# UNITED STATES PATENT AND TRADEMARK OFFICE

10/518,360

<b>Office Action Summary</b>	<b>Application No.</b> 10/518,360	<b>Applicant(s)</b> SOMMER ET AL.	
	<b>Examiner</b> Michael J. Keller	<b>Art Unit</b> 4136

## **DETAILED ACTION**

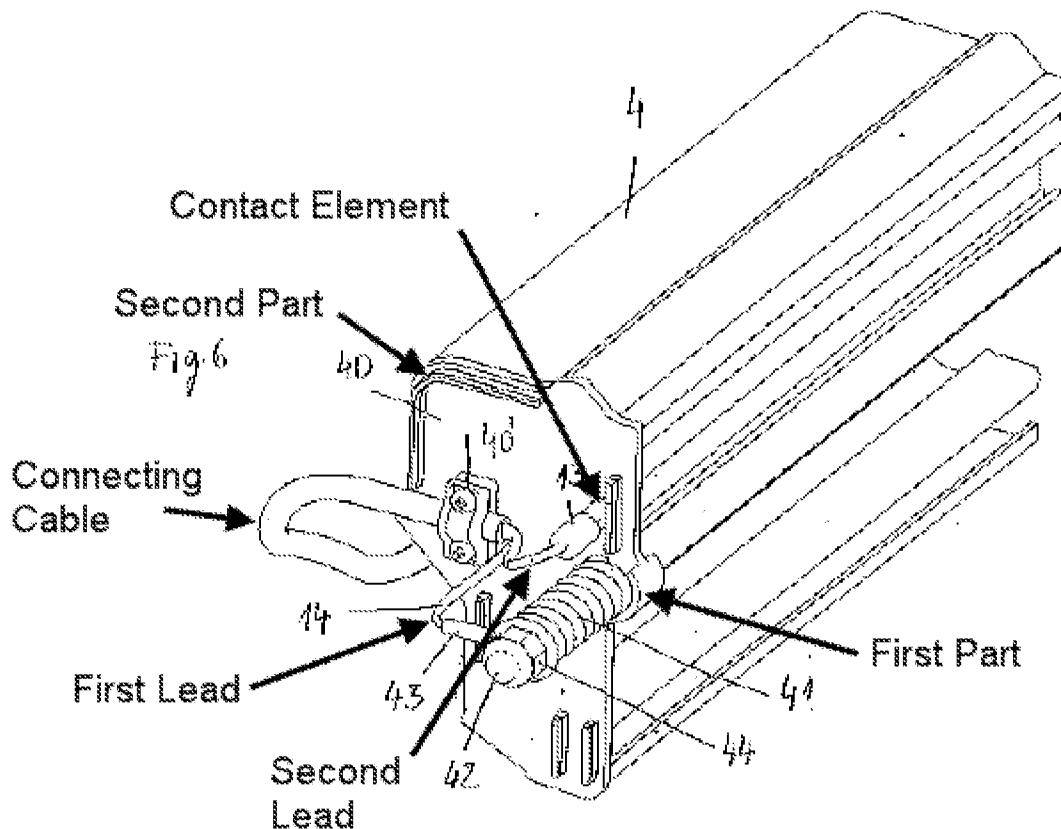
12. **Claims 1, 3-5, 7, 8, 11 and 14- 20 are rejected under 35 U.S.C. 102(b) as being anticipated by Sommer et al. (DE 198 08 696).** Sommer et al. discloses **[claim 1]** a drive device for a door comprising: a guide device comprising a rail (4,5) extending in a movement direction of the door; a carriage (6) to move along said guide device and comprising an electric motor (21) to cause movement of a door leaf (1), and further comprising a current feed connecting the electric motor with a current source, the current of which is supplied at one end of the guide device (translation page 2 paragraph 1 lines 8-11); wherein said current feed comprises a first insert body (40) to be plugged into an end of the guide device and a connecting cable (see Fig. 6 below), said current feed being arranged to be capable of being used at either end of said guide device (cover 40 is usable on the right and the left; translation page 2 paragraph 7 line 3); **[claim 3]** wherein the current feed comprises said rail and a traction means (35), the traction means to be connected at one end of said rail with a connecting cable using a traction means tightening device (41), and wherein the first insert body further comprises a contact body to contact said rail; **[claim 4]** wherein the first insert body comprises a first part to carry the traction means tightening device, and a second part to

provide an encircling abutment for an end of said rail; **[claim 5]** wherein the first part and the second part are integrally connected together (see Fig. 6 below).

guide device, wherein the first insert body includes a traction mechanism tensioning device (41) with a positive interlocking part to lock in place the traction mechanism; **[claim 8]** wherein the first insert body is to be inserted optionally into either end of the guide device (translation page 2 paragraph 7 line 3); **[claim 11]** wherein the traction mechanism comprises a chain (35); **[claim 14]** wherein the guide device comprises a guide rail (4,5) that forms a component of the current feed; **[claim 15]** wherein the first insert body comprises: a first part to carry the traction mechanism tensioning device; and a second part to form an end stop at an end of the guide rail, the second part having an opening to permit accessing an adjustment device (44) of the traction mechanism tensioning device (see Fig. 6 above); **[claim 16]** wherein said adjustment device enables the positive interlocking part of the traction mechanism tensioning device to be adjusted in a longitudinal direction of the guide rail (translation page 2 paragraph 7); **[claim 17]** wherein the first insert body further comprises: a connecting cable; and one or more contact elements to make contact with the guide rail; **[claim 18]** wherein the traction mechanism tensioning device and the traction mechanism are connected to a first lead of the connecting cable (see Fig. 6 above); **[claim 19]** the first insert body further comprising a cover plate (40') to provide traction relief for the connecting cable; **[claim 20]** wherein at least one said contact element is connected to a second lead of the connecting cable (see Fig. 6 above).
